Notice of Meeting of the Historic and Architectural Review Commission of the City of Georgetown, Texas February 12, 2026

1.B 216-224 W 8TH ST (2026-3-COA)

1.C 1606 S. Austin Avenue (2025-66-COA)

1.D **403 S. Myrtle Street (2025-58-COA)**

Plans and Specifications - Elevations

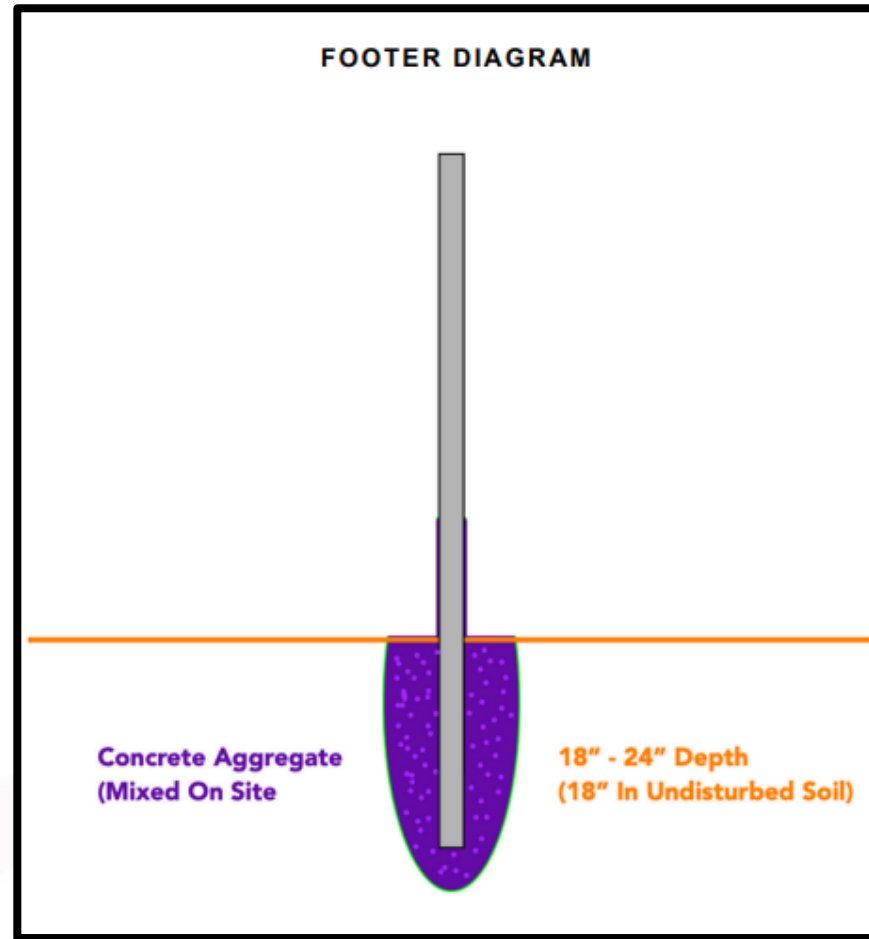
The applicant intends to increase the height of the existing 6'-0" front fence returns to 8'-0" in order to match the height of the previously approved fencing along the rear and side property lines. The applicant states that the proposed change is intended to provide consistent privacy, security, and a cohesive fence design across the property.

- The fence segment adjacent to the garage shall either remain at a maximum height of six feet (6'-0"), or be modified to incorporate a design with at least fifty percent (50%) transparency

Plans and Specifications – Front Elevation

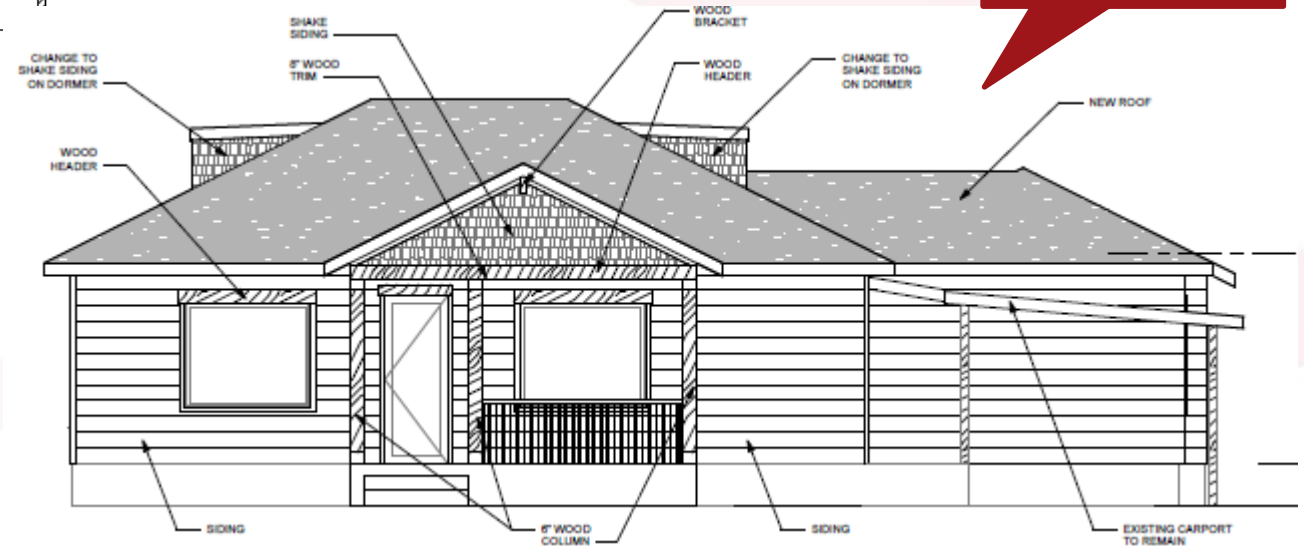
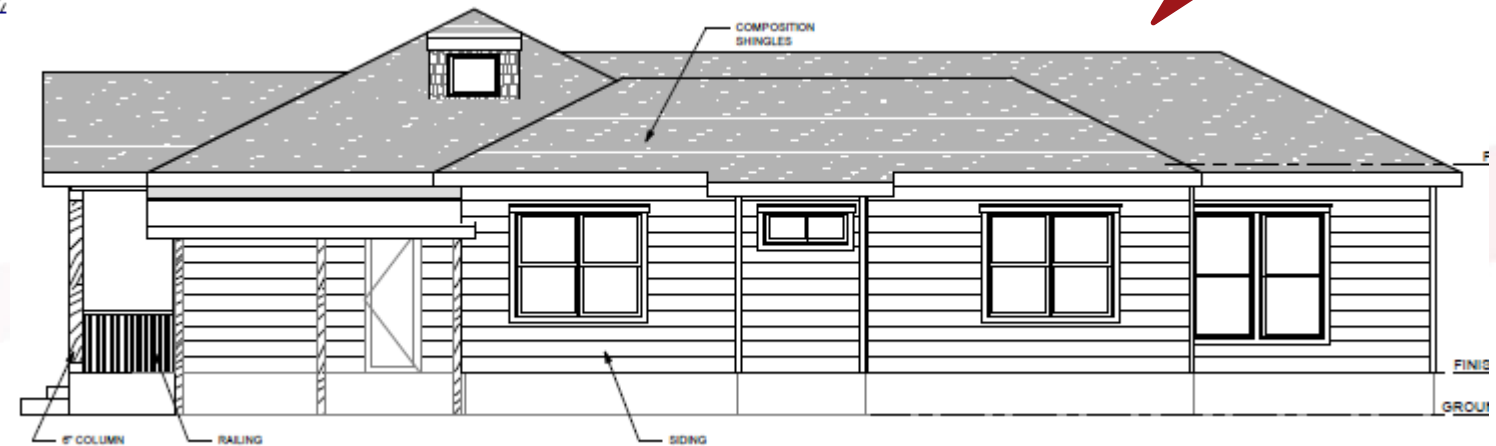
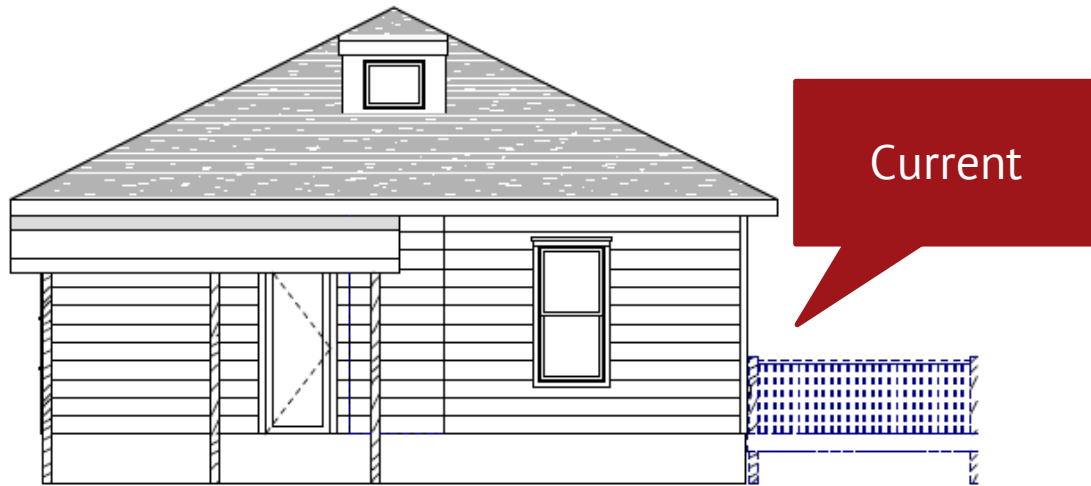
SECTION 3.13.030 CRITERIA	FINDINGS
7. The overall character of the applicable historic overlay district is protected; and	Complies The proposed street facing addition is setback from the front of the historic structure by approximately 12'-8", and is placed behind the existing carport allowing it to minimally impact the historic structure from the street. The proposed porch addition is in keeping with the overall character of the district.
8. The Master Sign Plan is in keeping with the adopted Historic District Design Guidelines and character of the historic overlay district.	Not Applicable Signage is not included with this request.

Based on the findings listed above, staff recommends **APPROVAL WITH CONDITIONS** of the request that include the following scopes of work: An addition that creates a new, or adds to an existing street facing façade, and a setback exception to allow a 3'-9" encroachment into the required side setback and a 17'-11" encroachment into the required front setback
